DRAWING CHANGE NOTICE:

DATE: 02-10-97
PROJECT NAME: VILLAGE 11/12 UNIT 2A IMPROVEMENTS
ALTA DRIVE
JOB NO. 62011.212
DCN NO. UNIT 2A - 10
AGENCY NO.

SUMMERLIN
VILLAGE 11/12 THE ARBORS - UNIT 2A
D.C.N. REVISION SHEET 2

SHEET
65B
SHT 65B OF 65

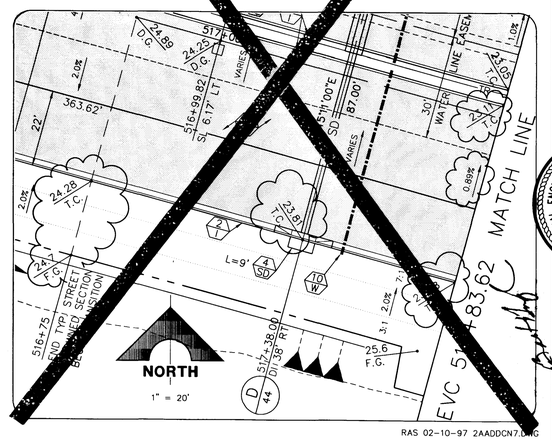
REVISION DESCRIPTION: ADJUST TC ELEVATIONS ON ALTA DRIVE ON WEST SIDE OF HUGHES INTERSECTION SHEET 12.

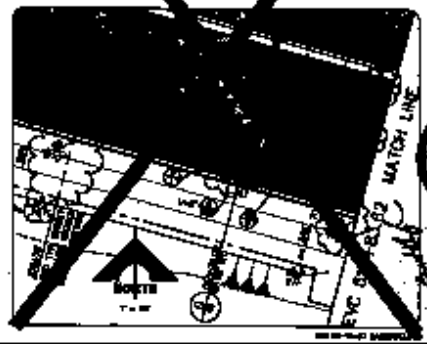
REVISION DESCRIPTION: ADD STEEL REINFORCEMENT BARS TO CIRCULAR CONCRETE RIBBON AT WEST END OF ARBORDALE PLACE.

1. CIRCULAR CONCRETE RIBBON AT WEST END OF ARBORDALE PLACE TO BE 9" THICK.
2. INCLUDE THREE NO. 5 STEEL REINFORCEMENT BARS LONGITUDINALLY AROUND CONCRETE RIBBON.
3. INCLUDE NO. 4 STEEL REINFORCEMENT BARS EVERY 18" RADIALLY AROUND CONCRETE RIBBON.
